RE: AC Hotel Midtown DC-2 CUP - Revisions

**CONDITIONAL USE PERMIT APPLICATION**

**AC HOTEL  
MIDTOWN DC-2**

**March 1, 2023  
Revised May 25, 2023**

**CUP 3**  
 PROJECT NO 24230006.00

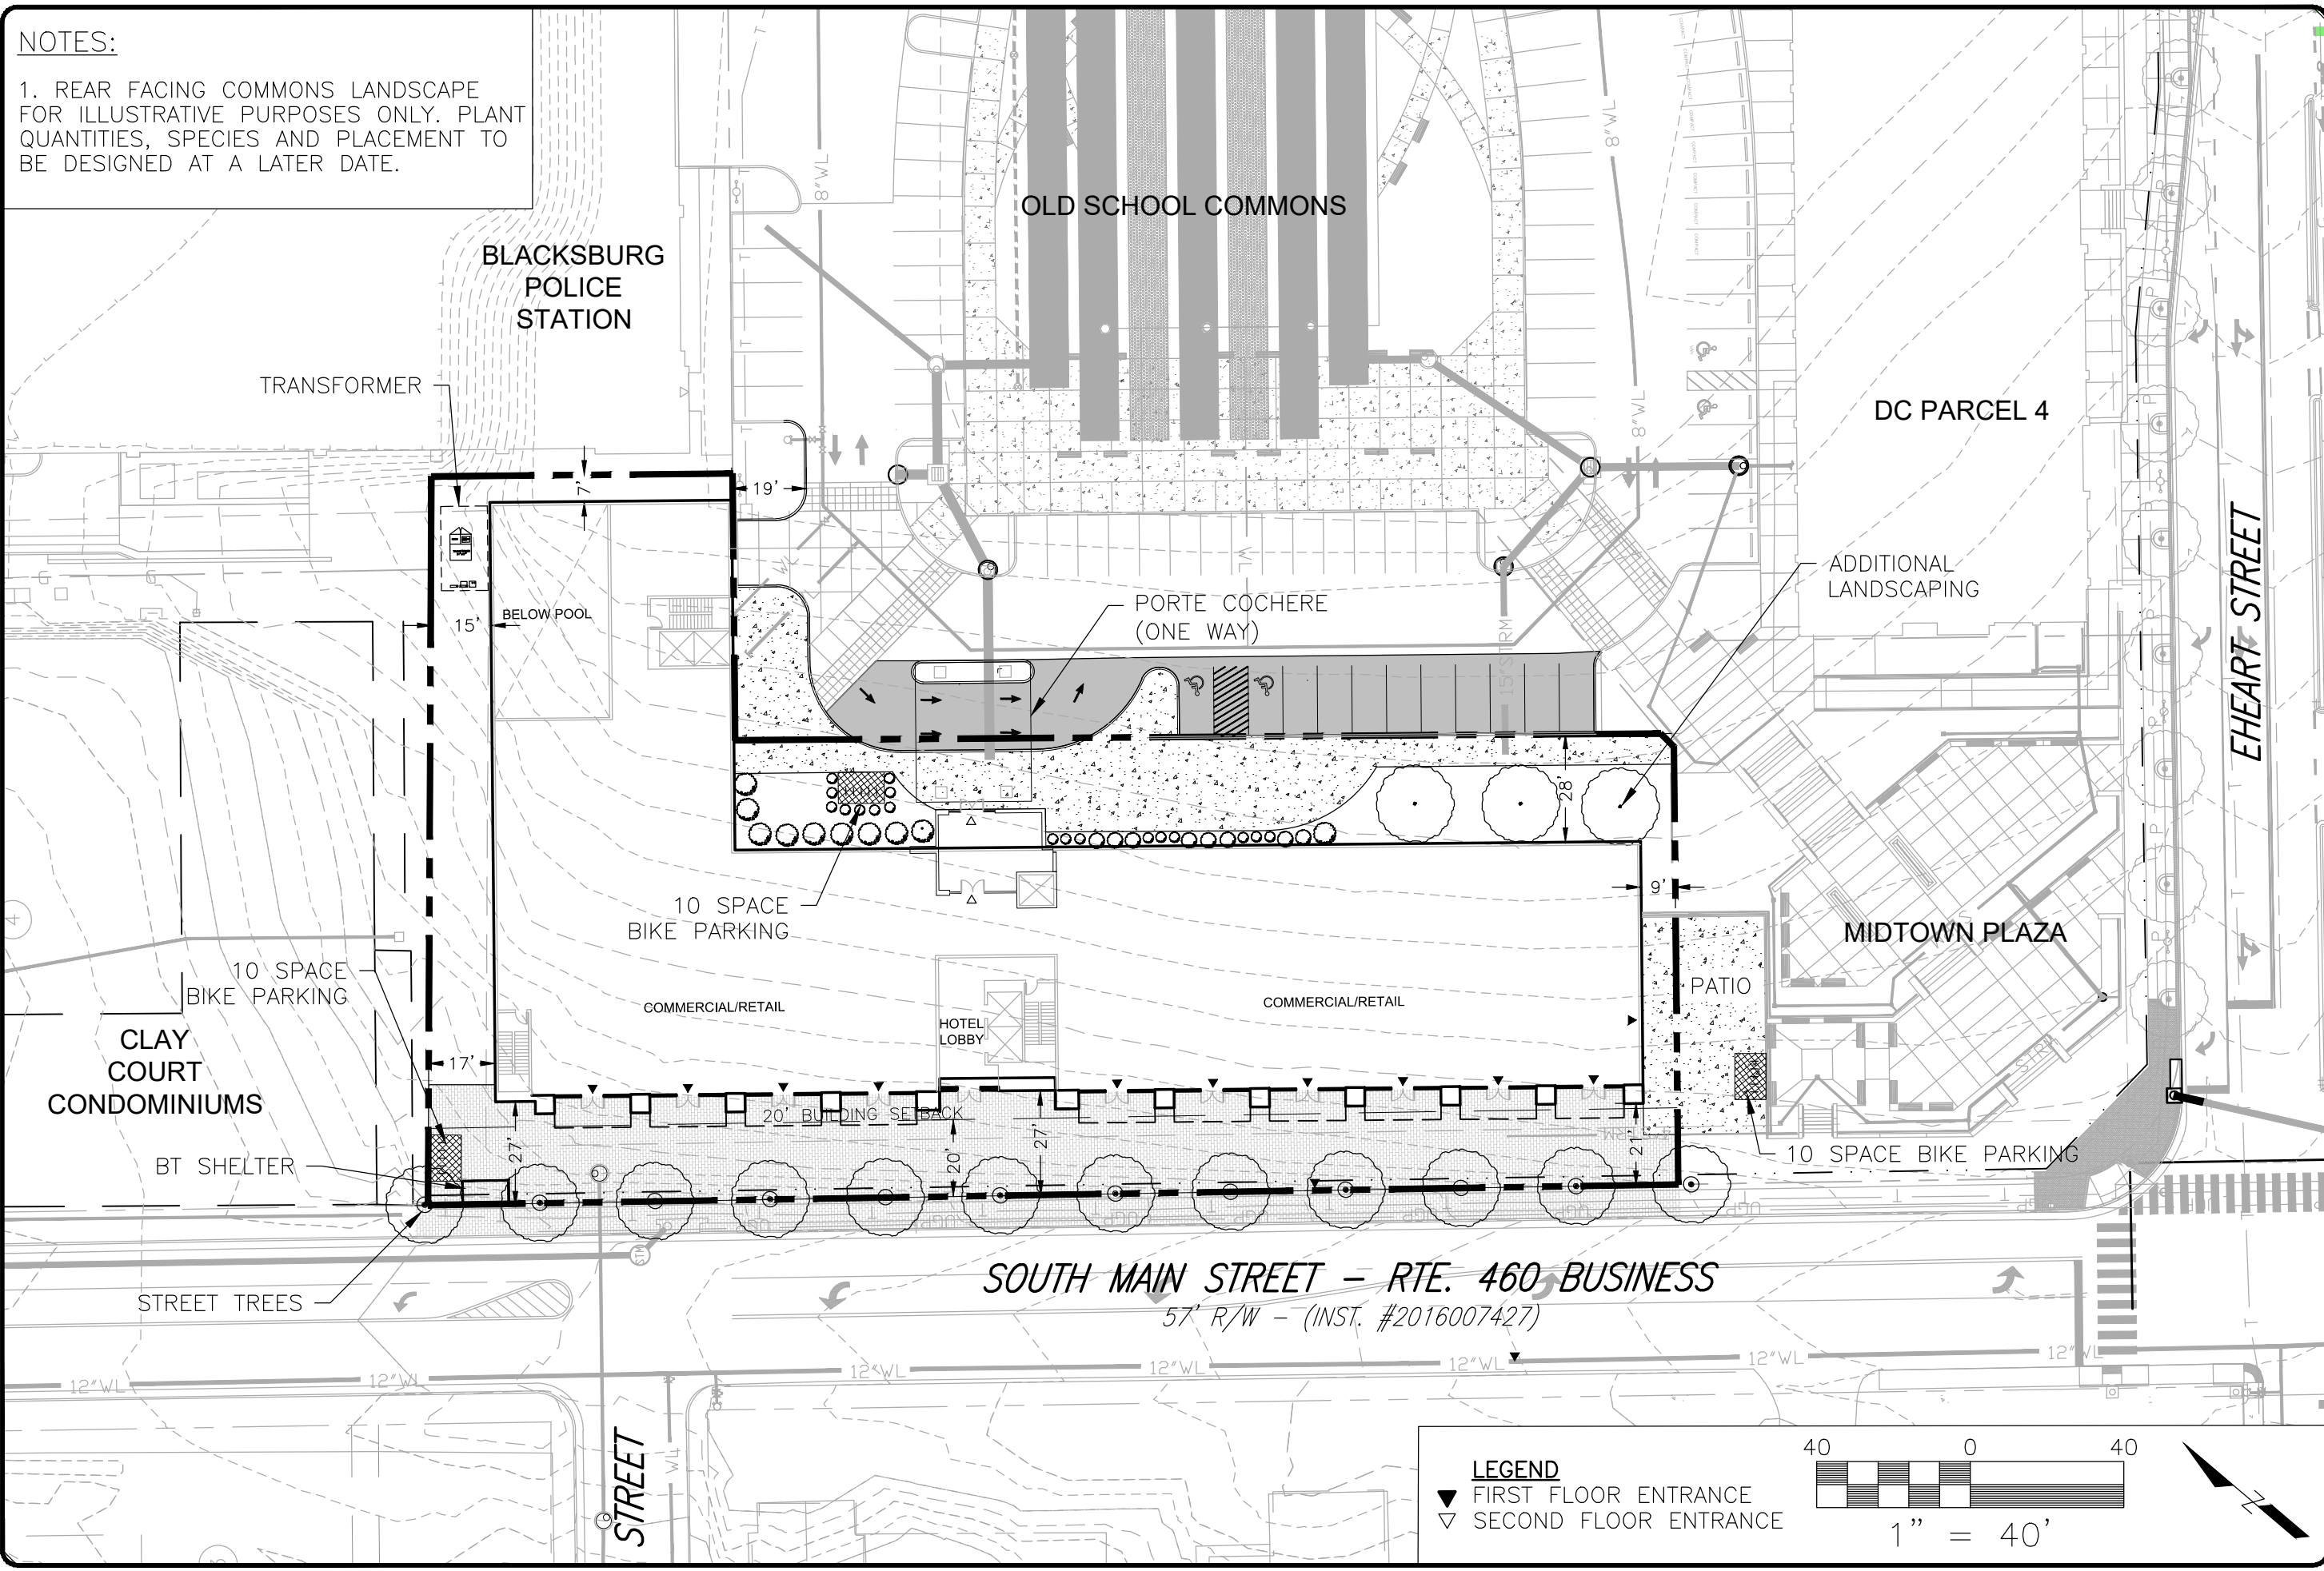
- 2) As the footprint of the building has changed, the masterplan drawing CUP3 has been revised to show those updates.
- 3) The total number of guest rooms in the hotel has dropped from 155 to 144 rooms.
- 4) Drawing CUP 4 has been added to the plan set. CUP 3 shows uses and detail of the Main Street level portion of the building and CUP 4 shows uses and detail of the Commons level portion of the building.

BUILDING ELEVATION - SOUTH MAIN STREET

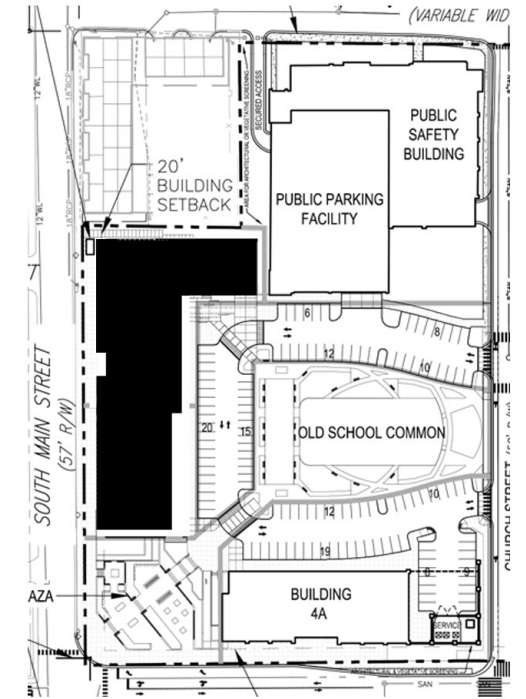
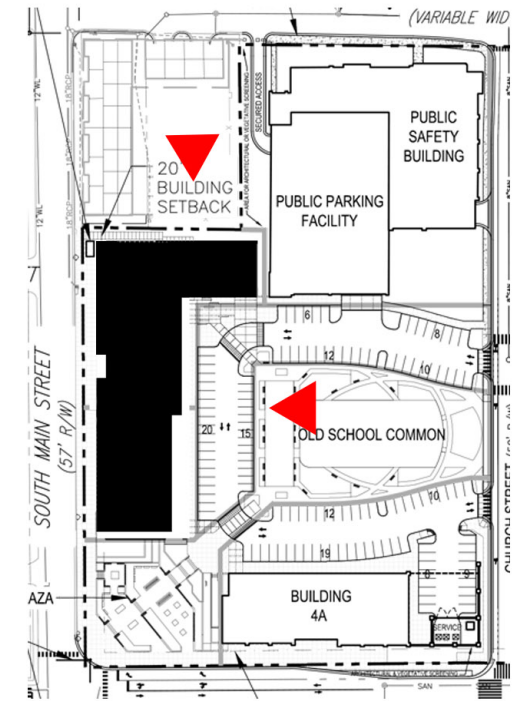
- 1) The Building facades have been adjusted based on further discussions with Town Staff and our Planning Commission Work Session Meeting on April 18<sup>th</sup>.

- Overall appearance of the building and material usage revisions along façades fronting South Main Street and the Commons.
- Building footprint and porte-cochere location have adjusted.
- Redesign of the southern end of the building that faces the Plaza.
- Floor plan layouts have shifted based on the redesign of the southern end of the building.
- Additional details regarding varying setbacks of the building facades.
- Enclosed rooftop area has been reduced and shifted further away from the front façade of the building.
- Enclosed rooftop area has been shifted to the north end of the building and the outdoor area in on the south end.
- Removal of South Main Street balconies and screenwalls.
